Request for Further Information

Application Number: CRC220756
Applicant Name: Lyttelton Port Company Limited
Activity Description: To renew CRC940431 - Discharge of coal dust into air

REVIEW OF THE LYTTELTON PORT COAL STOCKYARD AIR QUALITY ASSESSMENT

Figure 1.1: Coal dust deposition monitoring locations in surrounding environment.

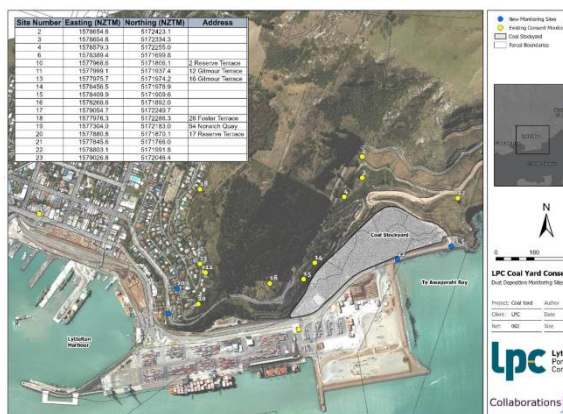
Figure 1 The data doesn't seem to match what the depositional model (figure 1.3) would predict. Monitoring point 17 is very low. Considering the depositional model prediction for this site this looks like there is an issue with the gauge equipment or perhaps how it is situated.
